# **SSD\_7056: CAMPBELL'S STORES, THE ROCKS MODIFICATION REPORT**

PREPARED FOR TALLAWOLADAH PTY LTD  
MARCH 2018

This Report has been prepared to support the Modification application for the Bay 12 area to facilitate the retention and preservation of the identified State significant archaeological material. The Modification relates only to the Bay 12 area. There are no changes proposed to Bays 1 to 11 of Campbell's Stores or the associated outdoor dining areas to the east and west.

Figure 5 – Photomontage of proposed amended Bay 12 area from Campbell's Cove

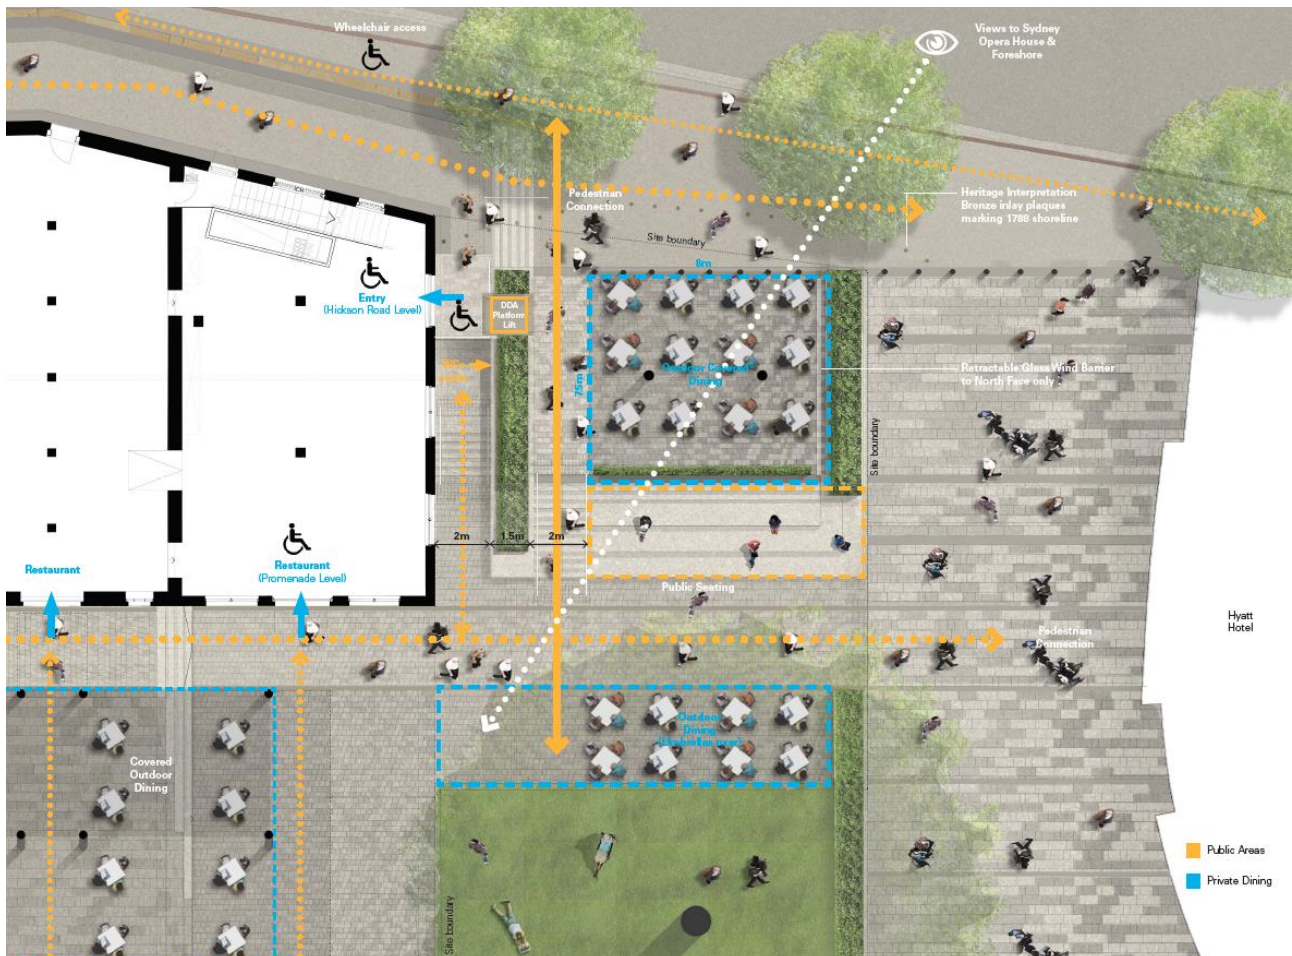
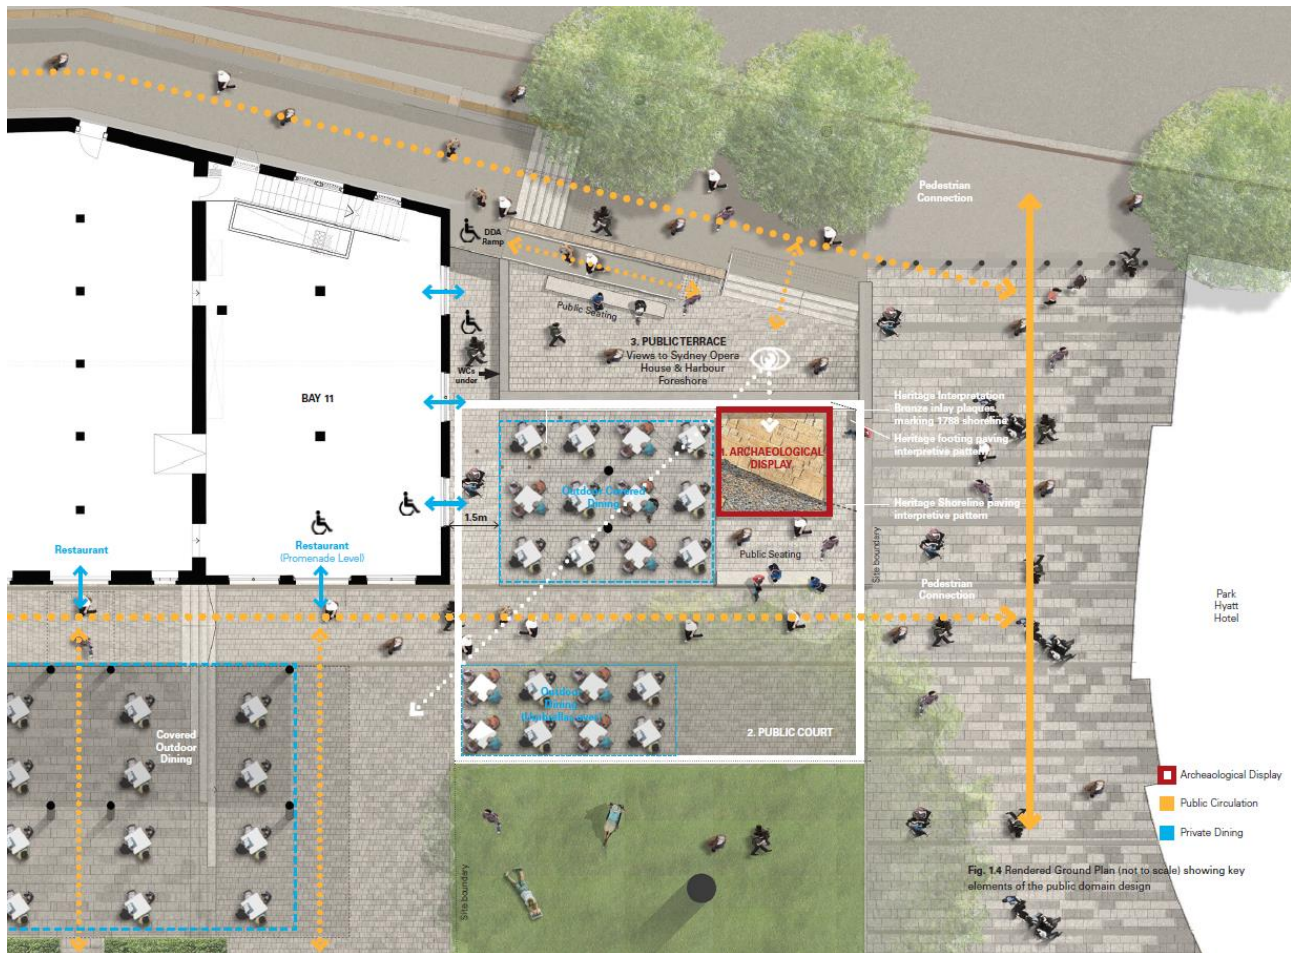
As described in Section 2, the discovery of State significant archaeological material within the Bay 12 area at the northern end of Campbell's Stores has necessitated a redesign of the previously approved landscaped terrace, outdoor dining area and associated awning, basement, services and drainage so that so that the remains can be conserved in situ.

- Creation of a viewing "window" into part of the in situ archaeology of an area of approximately 4.2 metres by 4.2 metres, to ensure that elements of the 1834 sea wall, sandstone paving and part of the 1834 bond store are visible and interpreted to the public.

- Permanent in situ conservation of all the archaeological features below the proposed developments in the Bay 12 area. The parts of the excavated archaeological site that will not be visible in the viewing window are to be carefully backfilled.

- Amendments to the design and location of the toilets, which are to be relocated to the west side of the site adjacent to, and built off, the extant Hickson Road retaining wall and its footings.

- Amendments to the design and location of the outdoor dining area so that it lies entirely to the south of the viewing window. Note: there are no changes to the amount of outdoor dining provided in the Bay 12 area.

- The creation of two public viewing areas on the east and west sides of the window to view the archaeology.
- Removal of two grease pump-out pits and associated plumbing from the Bay 12 area.

- Construction of additional subsoil drainage so as to drain the archaeological remains visible in the window.
